## **Access Compliance Report Public Rights-of-Way** (Curb Ramps)

Main Street: ASCENSO AVE **Cross Street: SENDERO WAY** Location: ADA ID: RPRK211117153405 Ramp Type:Type 1 - Perpendicular Initial Pass/Fail: Fail **Overall Compliance: No Severity Score:** 15

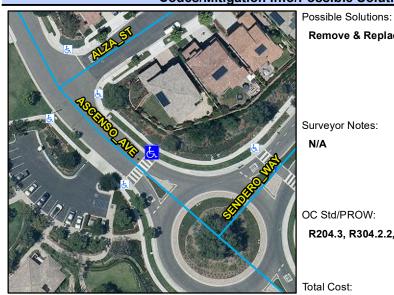
Remove & Replace Entire Ramp.

R204.3, R304.2.2, STD 1115
